Access Compliance Report Public Rights-of-Way (Curb Ramps)

Main Street: MALENA_DR Cross Street: SANTA_CLARA_AVE Location: NE

ADA ID: RPAT211019093606 Ramp Type: Type 1 - Perpendicular Diagonal Initial Pass/Fail: Pass Overall Compliance: No Severity Score: 0

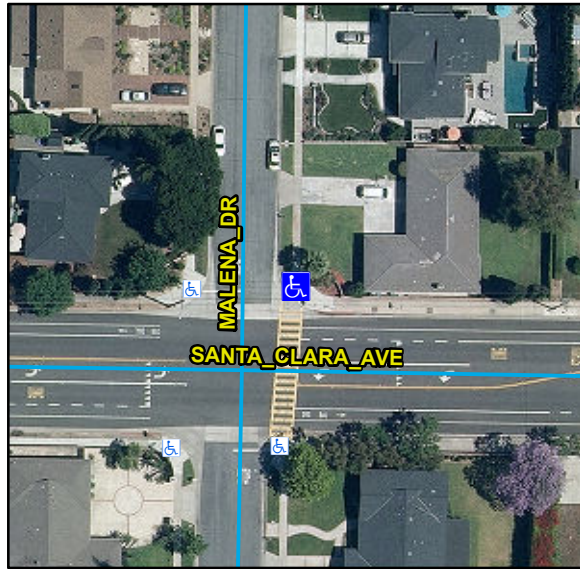
Compliance	Description	Data	Compliance	Description	Data
N/A	Ramp Length (in)	85	N/A	Flare Type LT	
Yes	Ramp Width (in)	49			Sloped
Yes	Ramp Run Slope (%)	7.3	N/A	Flare Slope LT (%)	6.8
Yes	Ramp Cross Slope (%)	1.4	N/A	Flare Traversable LT	No
N/A	Landing Present	Yes	N/A	Flare Type RT	
N/A	Landing Length (in)	50			Sloped
Yes	Landing Width (in)	49	N/A	Flare Slope RT (%)	6.4
Yes	Landing Run Slope (%)	0.8	N/A	Flare Traversable RT	No
Yes	Landing Cross Slope (%)	0.8	Yes	DWS Provided	Yes
N/A	Landing Movement Obstructed?	Yes	Yes	DWS Contrast	Yes
	Landing Movement Type	Curb	Yes	DWS Length (in)	36
N/A	Landing Shared	No	Yes	DWS Full Width	Yes
N/A	Clear Space	Yes	Yes	DWS Offset Left (in)	0
N/A	Clear Space To Crosswalk (in)	48	Yes	DWS Offset Right (in)	N/A
N/A	Marked Crosswalk 1	No	N/A	Marked Crosswalk 2	Yes
	Crossing 1 Direction	W		Crossing 2 Direction	S
	Marked Crosswalk 1 Width (in)	N/A		Marked Crosswalk 2 Width (in)	120

N/A	Ramp Inside Crosswalk 1	N/A	Yes	Ramp Inside Crosswalk 2	Yes
	Crossing 1 Slope (%)	1.7		Crossing 2 Slope (%)	9.2
	Crossing 1 Cross Slope (%)	3.1		Crossing 2 Cross Slope (%)	0.3
Yes	Gutter Ponding	No	No	Curb Slope	11.6
Yes	Gutter Lip Height (in)	0		Road Run Slope (%)	1.3
Yes	Gutter Run Slope (%)	3.1		Road Cross Slope (%)	1.8
Yes	Gutter Cross Slope (%)	1.2			
Yes	Overall Surface Condition: Acceptable		Yes	Perp Joint Present	Yes
	Cross Gutter Present?	Yes		Spandrel Present?	Yes
	Replace Cross Gutter?	No		Replace Spandrel?	No

Remove & Replace Curb Ramp With Two New Directional Ramps or Equivalent.

R304.2.2, R304.2.1, STD 1115
